ANALYSIS OF BELLEFONTE
MAIN STEAM GUARD PIPE
DURING A POSTULATED PIPE RUPTURE

BELLEFONTE NUCLEAR PLANT

CEB-78-14

RESPONSE TO NRC REQUEST FOR ADDITIONAL INFORMATION
ON TOPICAL REPORT CEB-76-25, REVISION 1

FIGURE 4-2-1 GUARD PIPE FINITE ELEMENT MODEL

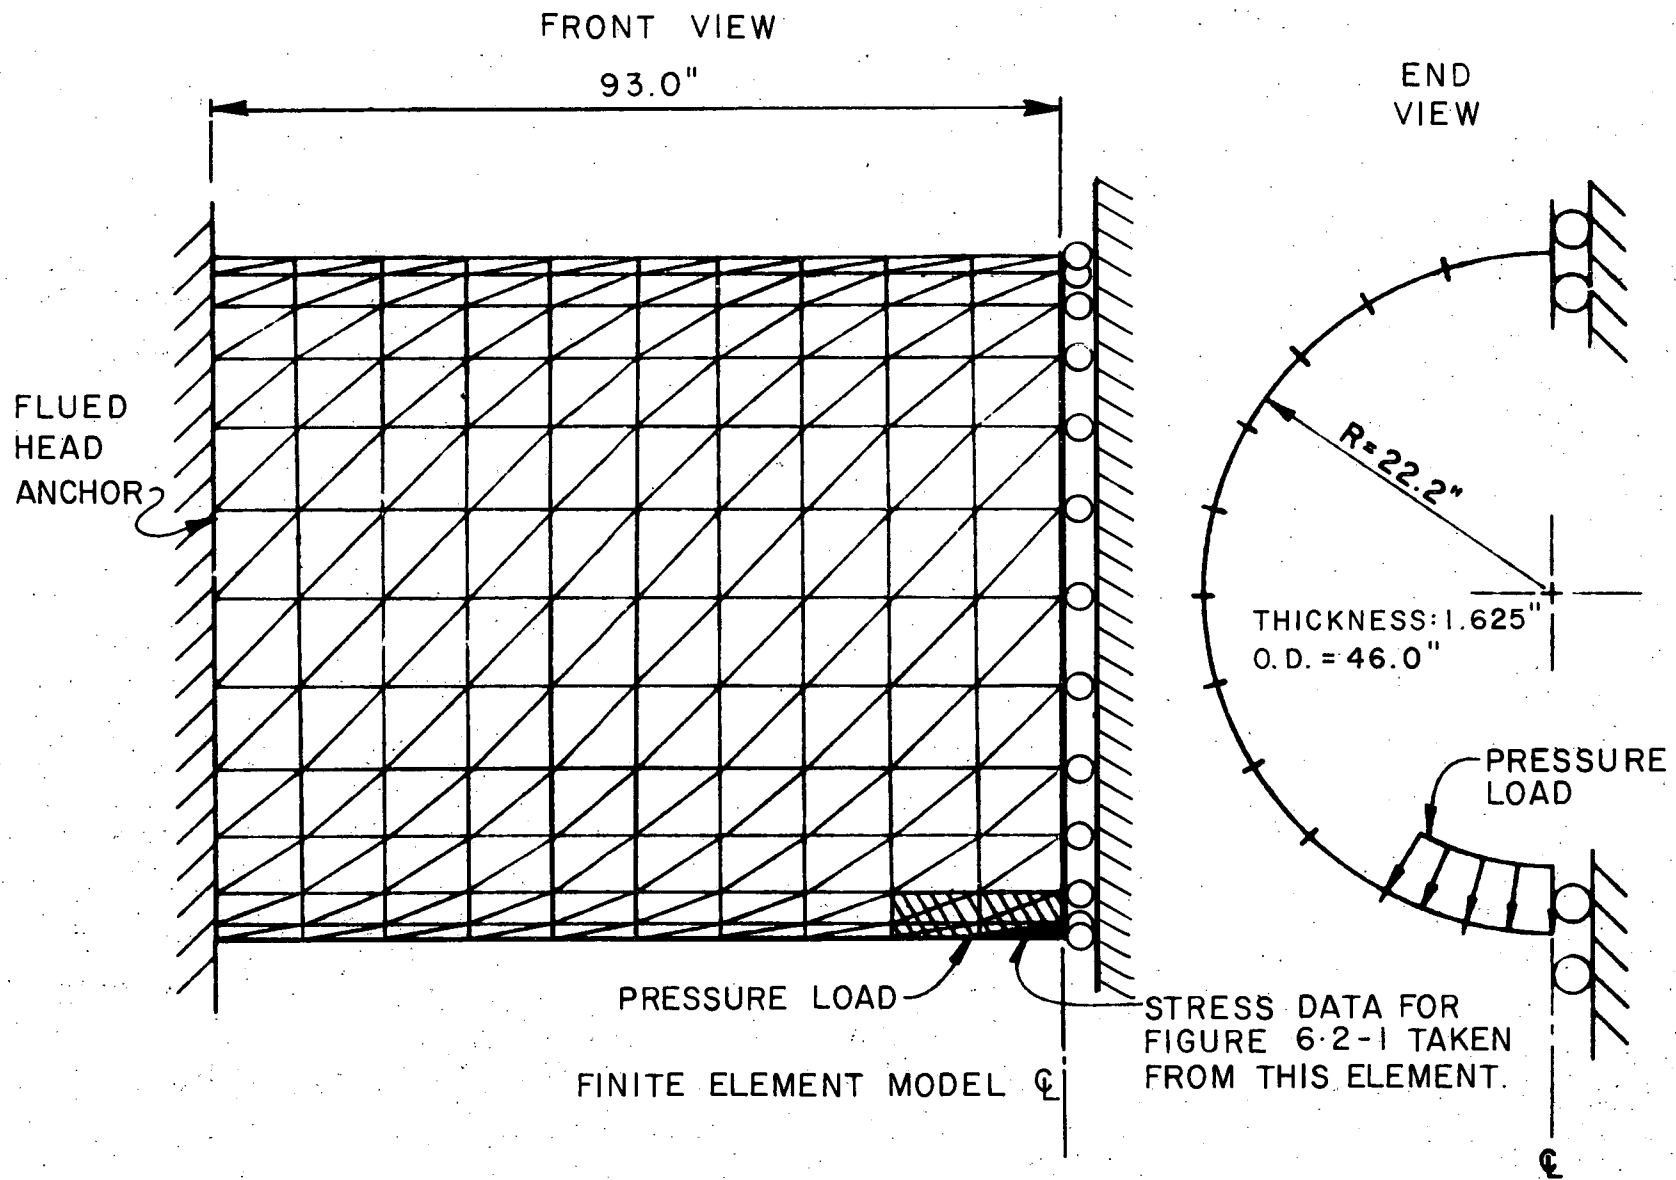
2. In Section 9.0(b) the structural model of the guard pipe was given as a statically indeterminate beam. This model is considered to be inadequate in providing the stress levels developed from either the jet force or for a pipe impact load. A statically indeterminate, thick walled circular shell model appears to be more appropriate for this analysis. Determine the stress levels under the postulated rupture condition using such a shell model; or, alternatively, provide justification that the use of the statically indeterminate beam model results in more conservative calculated stress levels as compared with the circular shell model.

Since the original analysis referred to in Section 9.0(b) of CEB-76-25, Revision 1, was performed, a more detailed analysis has been conducted. This analysis is a more rigorous finite element nonlinear dynamic analysis which considers the statically indeterminate beam as a shell structure. This is in accordance with the NRC recommendation.

The results of this analysis show that the computed stress levels are within allowable limits.

The results of this finite element analysis are documented in Topical Report CEB-78-14, Revision 1.

FIGURE 6-1-1 MAIN STEAM PIPE DISPLACEMENT - TIME HISTORY AT POINT OF LOADING

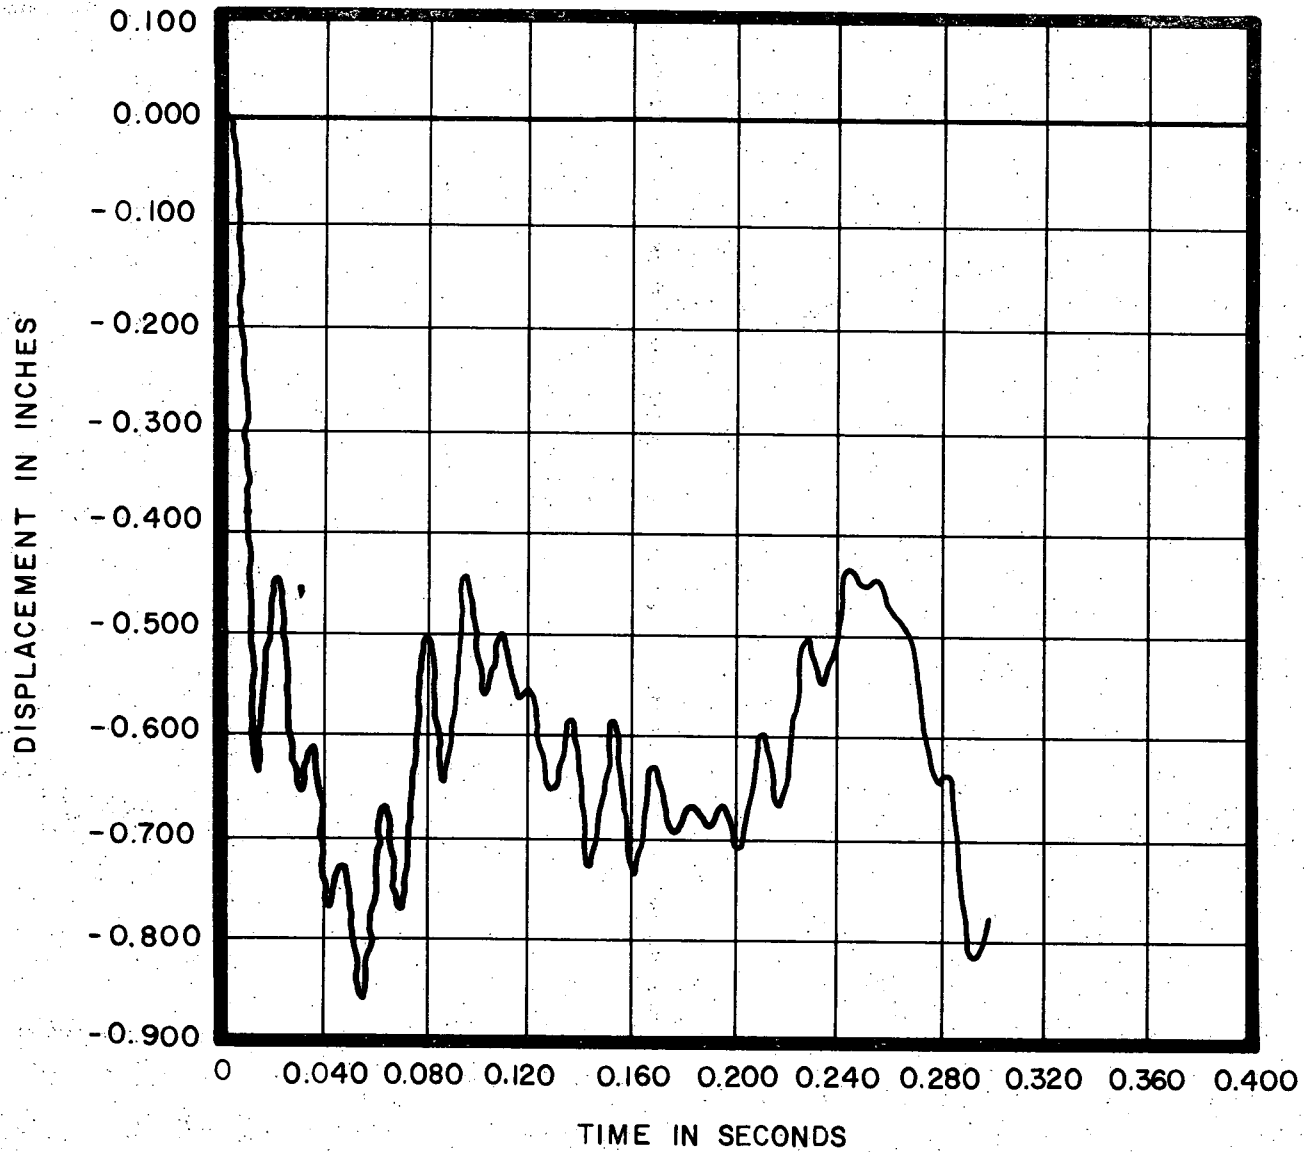
1. Provide the methodology for determining the pipe impact loads required for evaluating the dynamic effects associated with pipe rupture. In Section 7(f) it is indicated that the impingement loads govern the design of the guard pipe insofar as the pipe rupture loads are concerned. Provide justification for arriving at this conclusion.

A finite element analysis has been performed for the actual piping arrangement that shows that under the most adverse postulated break location process pipe impact on the guard pipe cannot occur. This conclusion is documented in Topical Report CEB-78-14, Revision 1.
